September 7, 2023  
GS# 320-092, PEARL PROB. & PAROLE RE-ROOF  
Department of Corrections, Pearl, MS

### Addendum No. 1

SHEET  
**A201**  
 ROOF DETAILS

**IN SOME LOCATIONS, THE GUTTER DOWNSPOUT AND SCUPPER DOWNSPOUT ARE IN LINE WITH EACH OTHER. OTHER LOCATIONS THEY ARE OFFSET. THIS ELEVATION VIEW SHOWS THE EXISTING GUTTER DOWNSPOUT "OFFSET" WITH THE SCUPPER DOWNSPOUT. SEE THE ADJACENT PLAN VIEW FOR ADDITIONAL INFORMATION.**

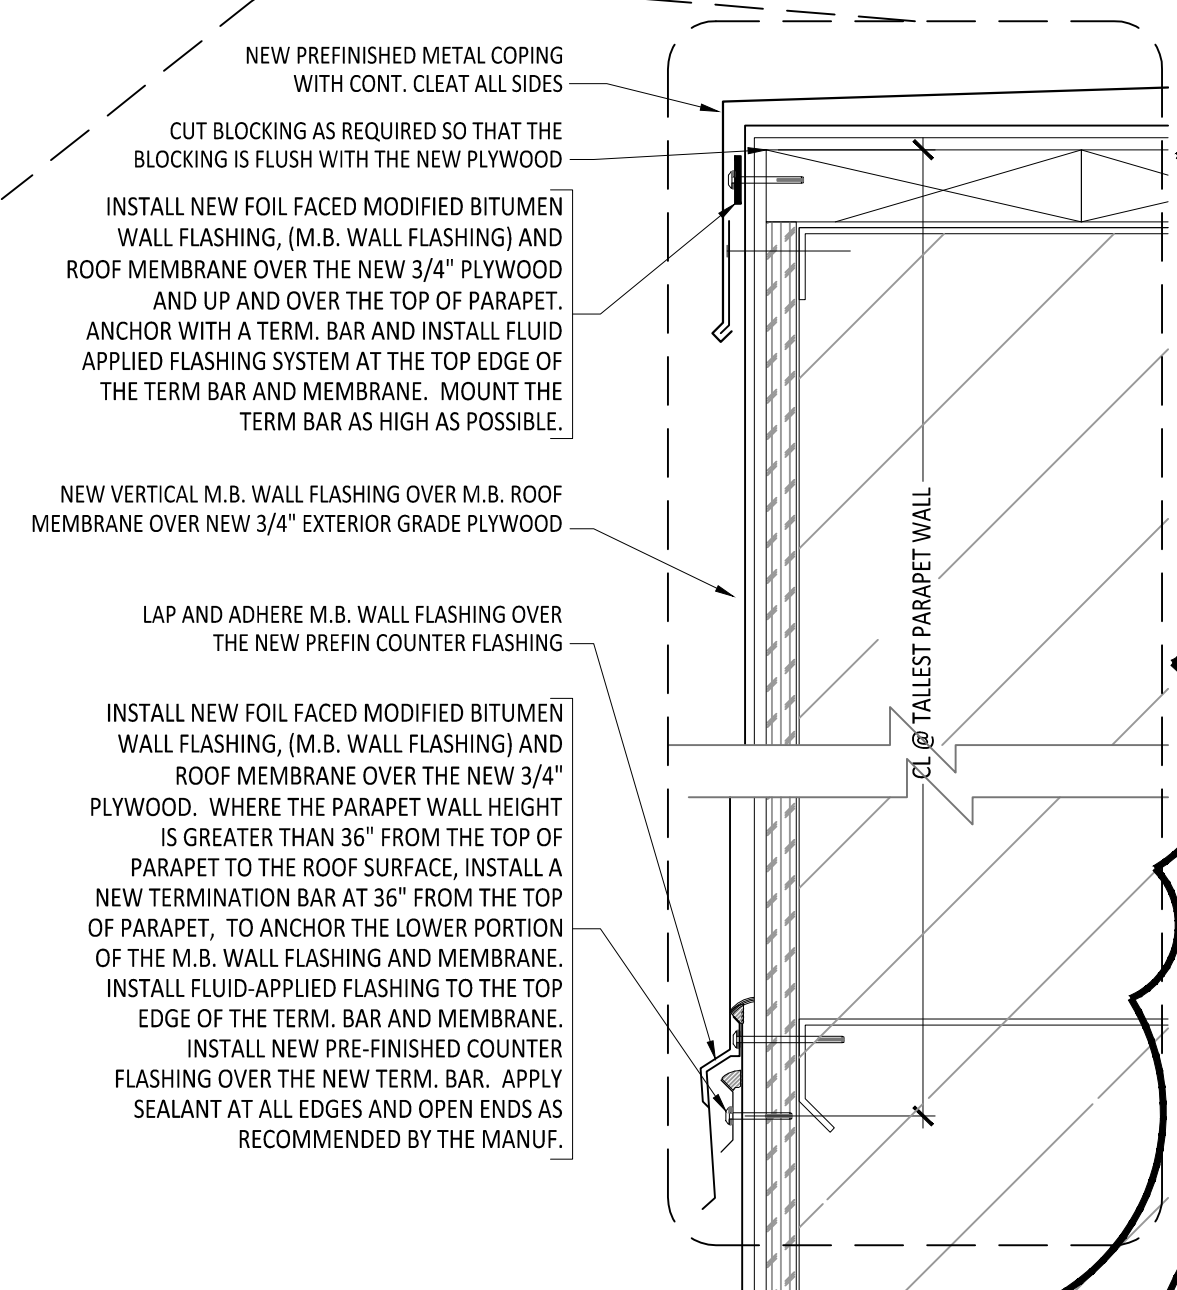
12. See the reissued drawing A201 for changes in the parapet detail and new through wall scuppers. Note that the new detail calls for infilling the existing integral gutter, creating new through wall scuppers and installing new collector heads and downspouts (verify locations). The scupper openings are to be 8" x8" minimum. New crickets will be installed between the new through wall scuppers. The exterior of the new scupper is to have a prefinished metal, 1-1/2" "picture frame" type flange around the perimeter in a color that reasonably matches the existing brick. The existing PVC drain outlets at grade will cut flush with the brick face and capped with a square piece of prefinished metal to match the brick color reasonably closely. The metal shall have hemmed edges and be attached to the brick with drive pins.

6. **See the reissued drawing A201 for changes in the parapet detail and new through wall scuppers. Note that the new detail calls for infilling the existing integral gutter, creating new through wall scuppers and installing new collector heads and downspouts (verify locations). The scupper openings are to be 8" x8" minimum. New crickets will be installed between the new through wall scuppers. The exterior of the new scupper is to have a prefinished metal, 1-1/2" "picture frame" type flange around the perimeter in a color that reasonably matches the existing brick. The existing PVC drain outlets at grade will cut flush with the brick face and capped with a square piece of prefinished metal to match the brick color reasonably closely. The metal shall have hemmed edges and be attached to the brick with drive pins.**
